TUESDAY, NOVEMBER 18, 2014
(COUNCIL CHAMBERS)

1. "State of the Foundation" report from College Park Community Foundation (request of Councilmember Dennis) - Richard Morrison (Chair) and Dave Milligan (Vice Chair)
2. Preliminary Plan and Detailed Site Plan for The Hotel at the University of Maryland – Terry Schum, Director of Planning
3. Recommendation for award of Business Recycling Grant – Loree O'Hagan, City Recycling Coordinator
4. Proposed updates to the City's recycling code – Bob Stumpff, Director of Public Works
5. Discussion of Buy Local efforts – Councilmember Wojahn
6. Revisit the City's "Prohibited continuous parking in excess of 48 hours on public roadways" law - Councilmember Wojahn
7. Discussion of site selection for City Hall and discussion of acquiring a portion of the Stone Industrial site

SUBJECT: Preliminary Plan of Subdivision 4-14009
Detailed Site Plan (DSP) 14022
The Hotel at the University of Maryland

NORTH BUILDING ELEVATION
DRAWING NOT TO SCALE

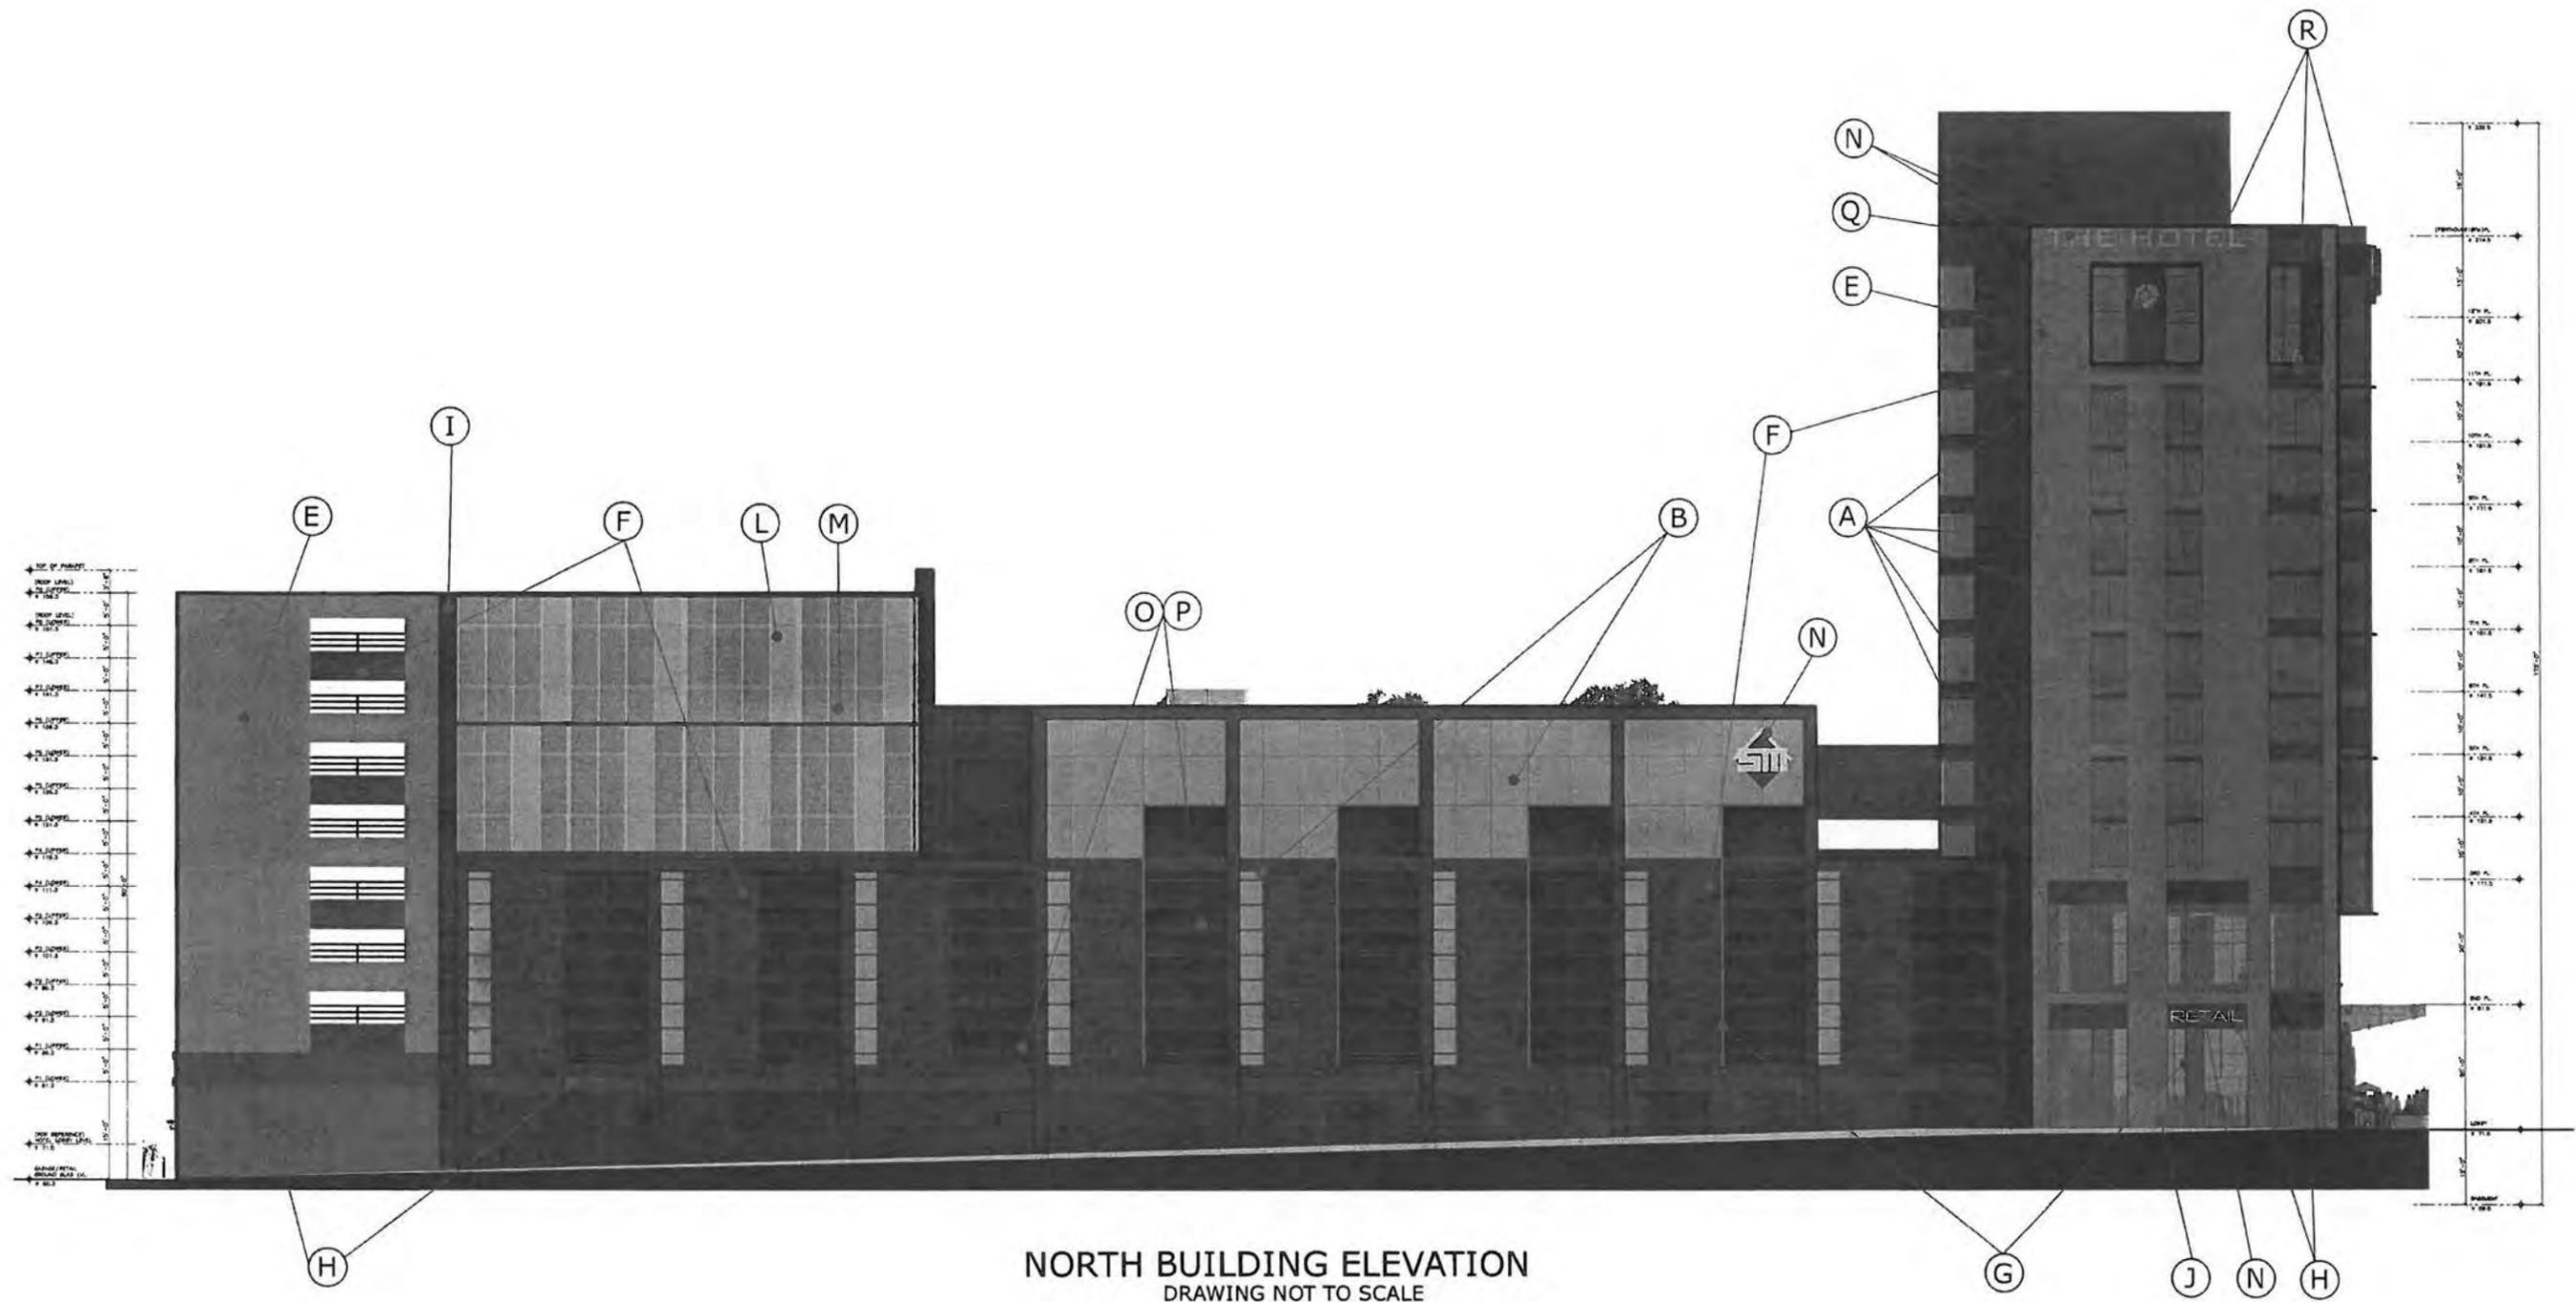
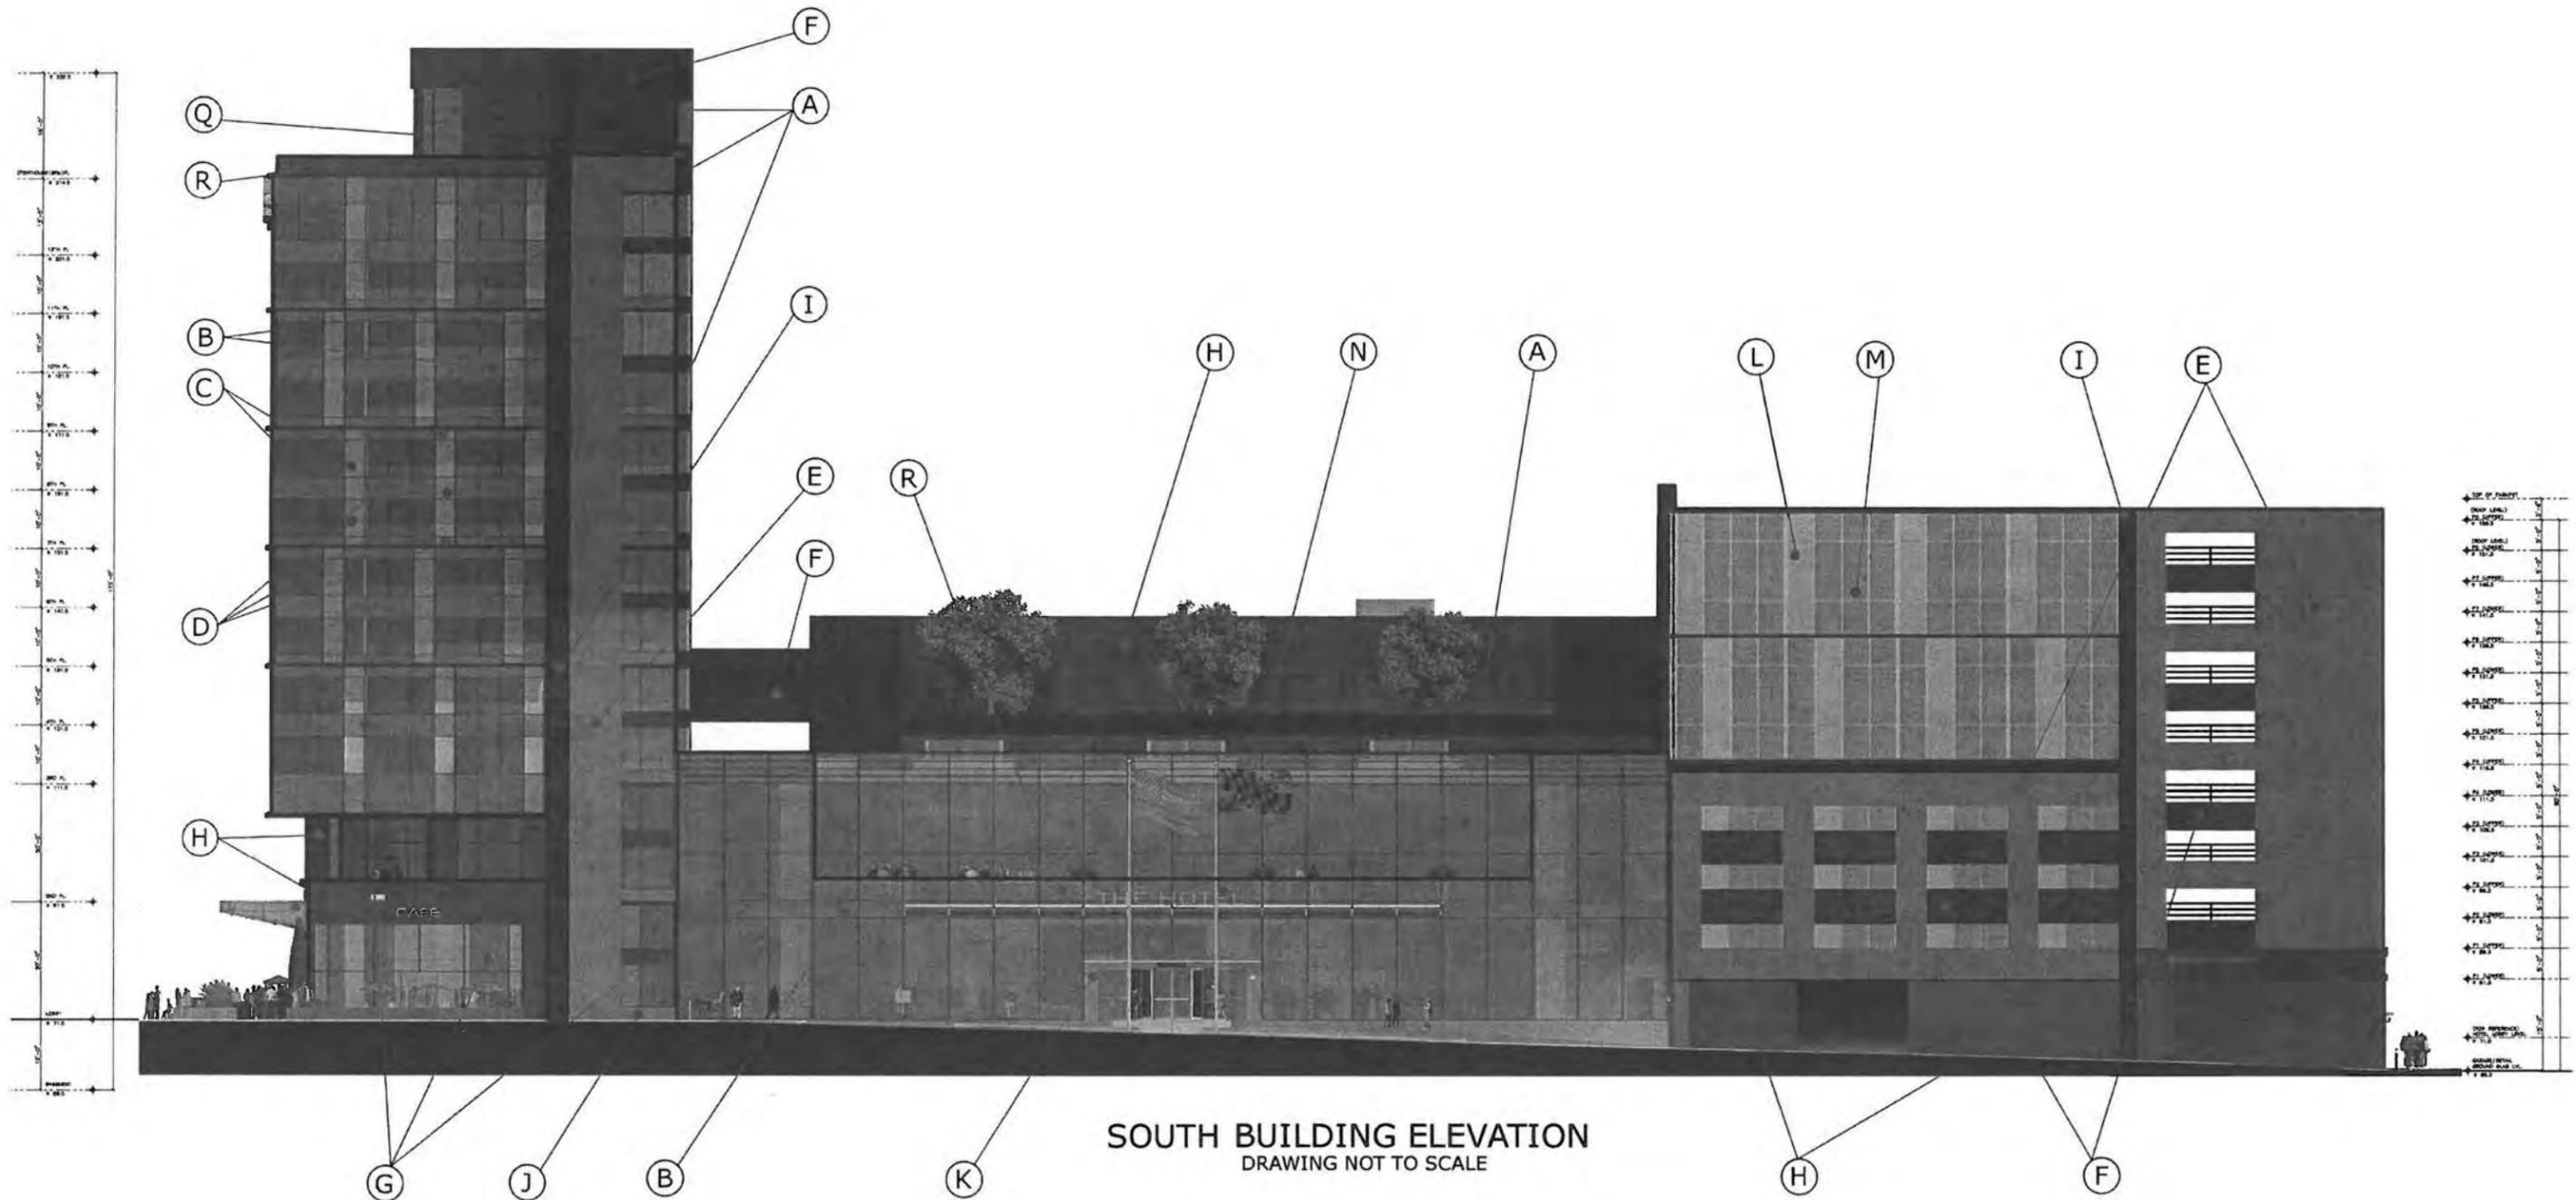
The Part 77 Horizontal Surface is 198 feet Above Mean Sea Level (AMSL) at this location. The hotel is proposed to be 233 feet AMSL which exceeds the FAA and COMAR standard by 35 feet. This has the potential to negatively affect the operation of the College Park Airport. It is our understanding that the MAA will have "no comment" on this application and the FAA is still conducting their review. We are in receipt of a letter from the College Park Airport Authority (Attachment 9) recommending that the height of the hotel be no greater than 198 feet above mean sea level or 150 feet above ground level and that the applicant obtain a "no hazard" determination from the FAA and MAA. Staff supports the building height modification subject to these determinations from FAA and MAA.

4. Electronic Message Center (EMC) signs. The applicant is proposing two 16.67-foot tall by 8-foot wide Electronic Message Center (EMC) signs located on the North and South Elevation of the building at a height of 80-feet. There is no mention of this type of signs in the Sector Plan. US1 is a very busy highway with University buildings and activities located along both sides of the road. Moreover, there is much pedestrian crossing activity at unauthorized locations. City staff is concerned that Electronic Message Center signs flashing messages could create further distractions to drivers on US 1 and create unsafe conditions. Therefore, City staff recommends that the Electronic Message signs not be permitted.

- b. A color and materials board.
3. Prior to signature approval, the Applicant shall revise the sign plan to:
 - a. Eliminate all electronic message center signs.

Monument Sign - Sculptural SCALE @ 1/2" = 1'-0"

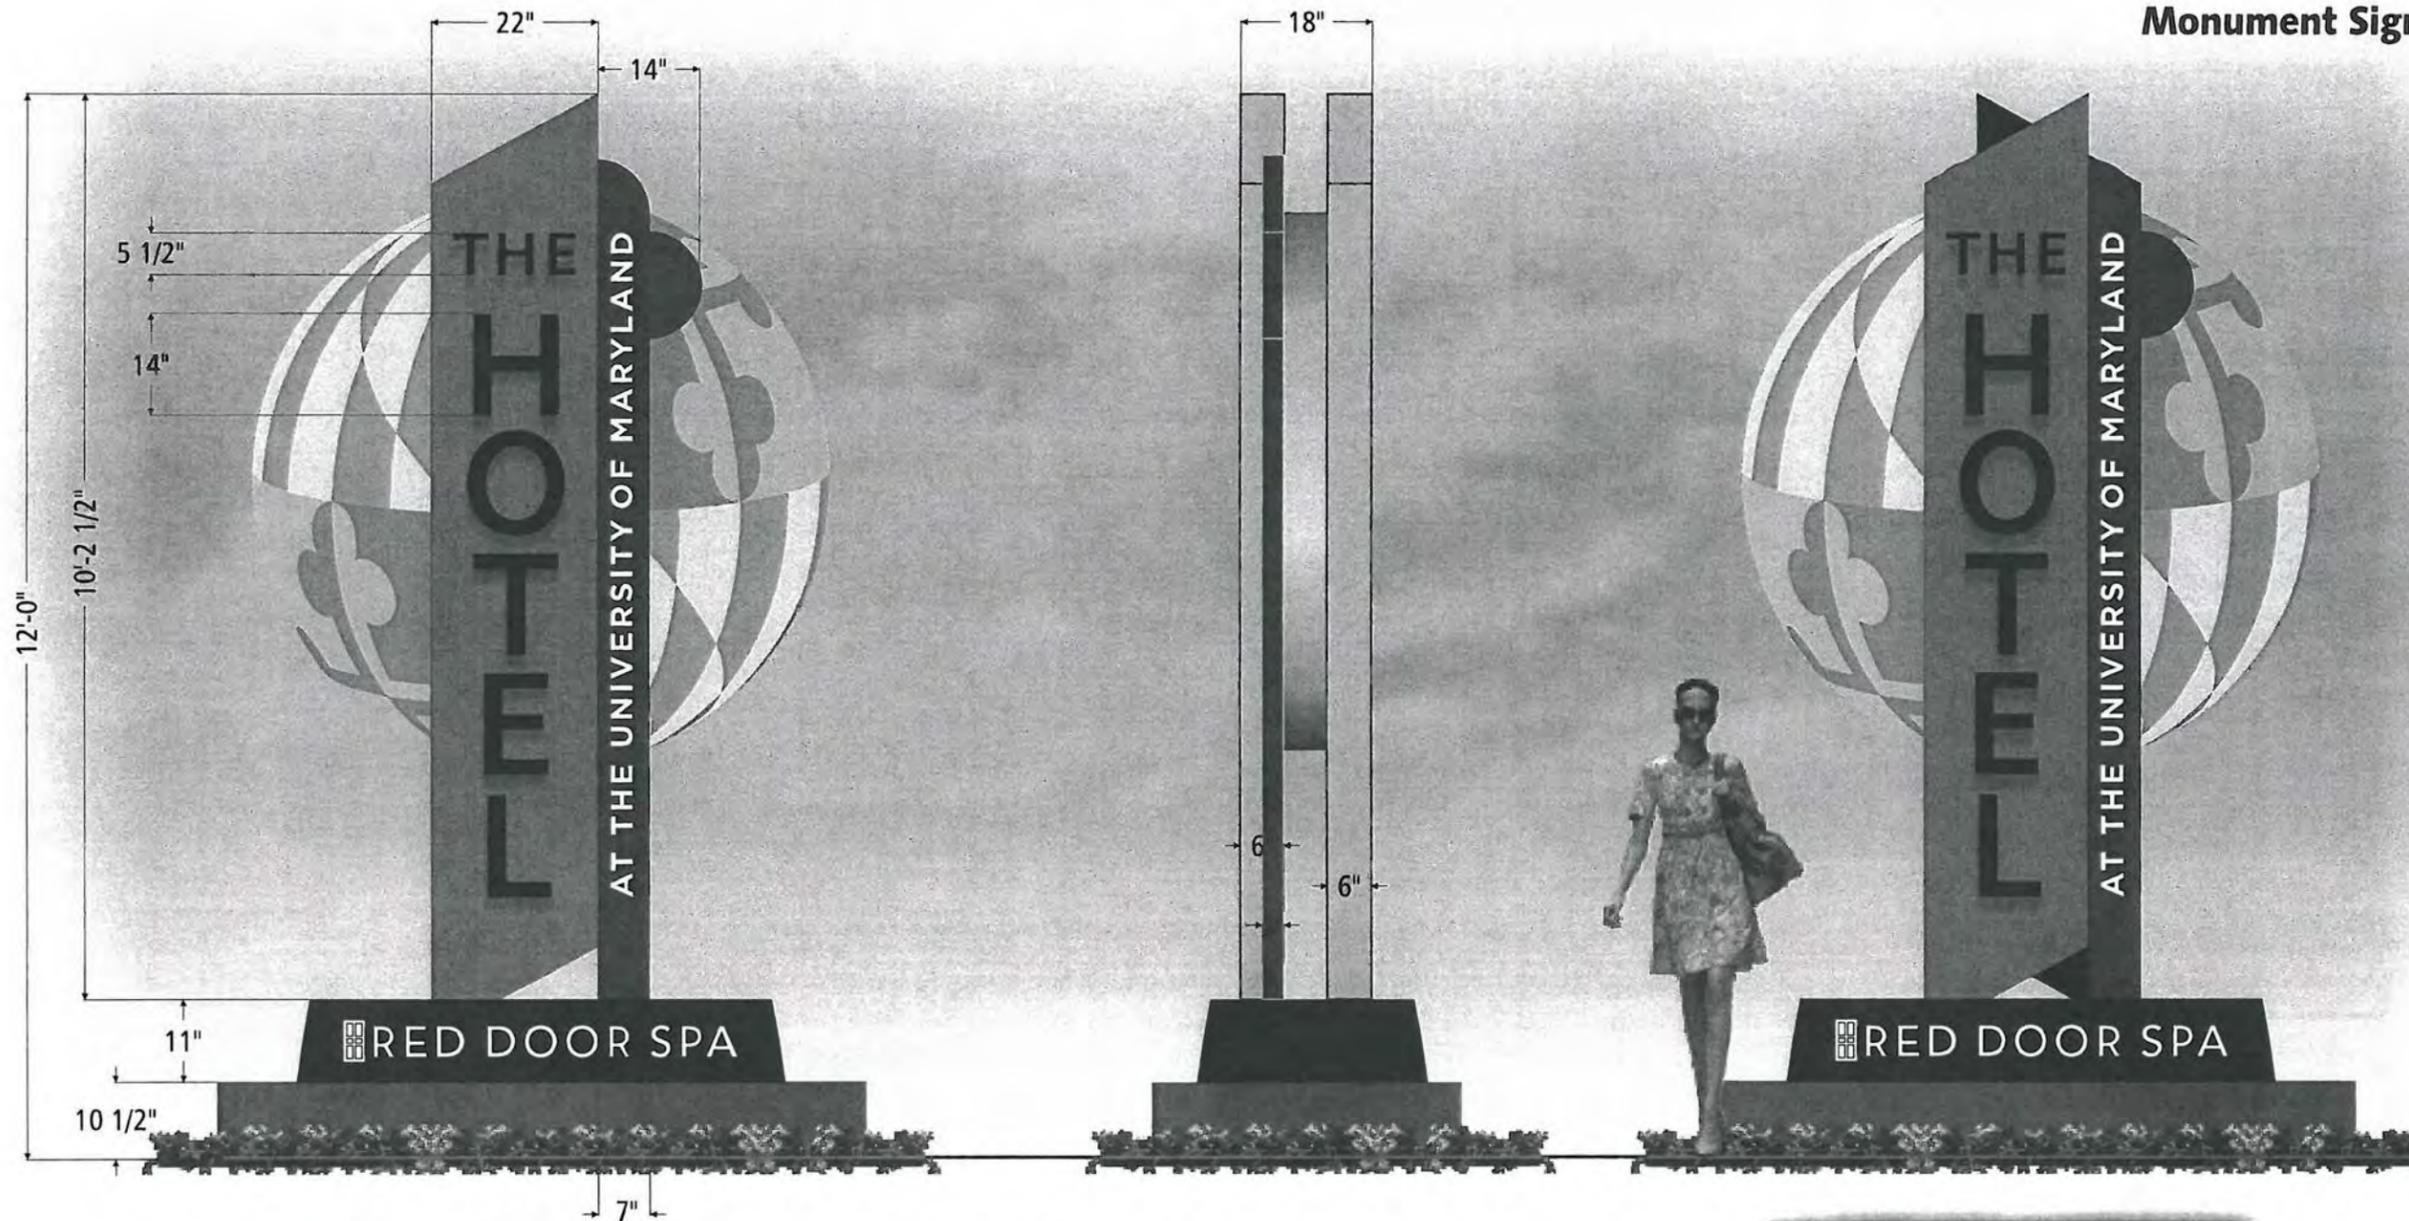
1. Free-standing sign modification. The applicant is proposing a free-standing sign on Route 1 but staff would prefer to see this sign removed or relocated to Hotel Drive South by the circle-drive entrance, possibly in the landscaped circle. An enhanced marquee sign, however, would be preferred at this location.

- b. Sign requirements prohibiting free standing signs.
2. Prior to signature approval, the Applicant shall provide:
 - a. A letter from MAA and/or FAA that demonstrates compliance with Zoning Ordinance Section 27-548.39 and 27-548.42.
